Access Compliance Report Public Rights-of-Way (Curb Ramps)

Main Street: **SUGAR_AVE** Cross Street: **CEDARWOOD_AVE** Location: **NW**

ADA ID: **RPRK211005180442** Ramp Type: **Type 1 - Perpendicular Diagonal** Initial Pass/Fail: **Fail** Overall Compliance: **No** Severity Score: **16**

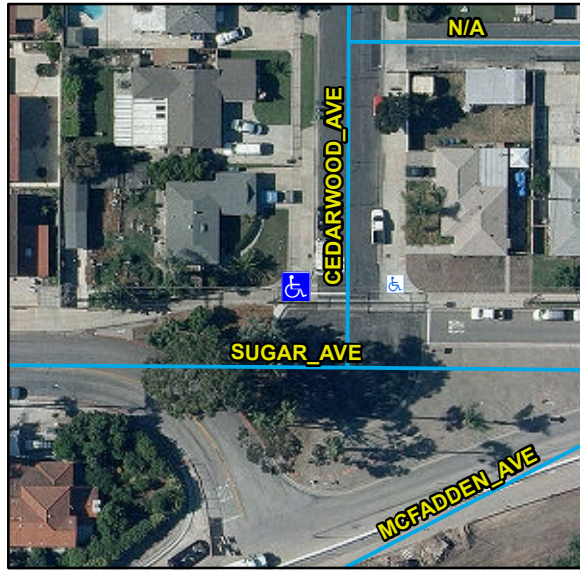
Compliance	Description	Data	Compliance	Description	Data
N/A	Ramp Length (in)	104	N/A	Flare Type LT	
Yes	Ramp Width (in)	48			N/A
No	Ramp Run Slope (%)	11.9	N/A	Flare Slope LT (%)	N/A
Yes	Ramp Cross Slope (%)	1.2	N/A	Flare Traversable LT	N/A
N/A	Landing Present	N/A	N/A	Flare Type RT	
N/A	Landing Length (in)	N/A			N/A
N/A	Landing Width (in)	N/A	N/A	Flare Slope RT (%)	N/A
N/A	Landing Run Slope (%)	N/A	N/A	Flare Traversable RT	N/A
N/A	Landing Cross Slope (%)	N/A	N/A	DWS Provided	N/A
N/A	Landing Movement Obstructed?	N/A	N/A	DWS Contrast	N/A
	Landing Movement Type	N/A	N/A	DWS Length (in)	N/A
N/A	Landing Shared	N/A	N/A	DWS Full Width	N/A
N/A	Clear Space	Yes	N/A	DWS Offset Left (in)	N/A
N/A	Clear Space To Crosswalk (in)	N/A	N/A	DWS Offset Right (in)	N/A
N/A	Marked Crosswalk 1	No	N/A	Marked Crosswalk 2	No
	Crossing 1 Direction	S		Crossing 2 Direction	E
	Marked Crosswalk 1 Width (in)	N/A		Marked Crosswalk 2 Width (in)	N/A

N/A	Ramp Inside Crosswalk 1	N/A	Yes	Ramp Inside Crosswalk 2	N/A
	Crossing 1 Slope (%)	5		Crossing 2 Slope (%)	1.5
	Crossing 1 Cross Slope (%)	5.1		Crossing 2 Cross Slope (%)	1.2
N/A	Gutter Ponding	N/A	No	Curb Slope	7.3
Yes	Gutter Lip Height (in)	0		Road Run Slope (%)	1.2
N/A	Gutter Run Slope (%)	N/A		Road Cross Slope (%)	4.9
N/A	Gutter Cross Slope (%)	N/A			
Yes	Overall Surface Condition: Acceptable		Yes	Perp Joint Present	Yes
	Cross Gutter Present?	Yes		Spandrel Present?	Yes
	Replace Cross Gutter?	No		Replace Spandrel?	No

Remove & Replace Curb Ramp With Two New Directional Ramps or Equivalent.

R304.2.2, STD 1115
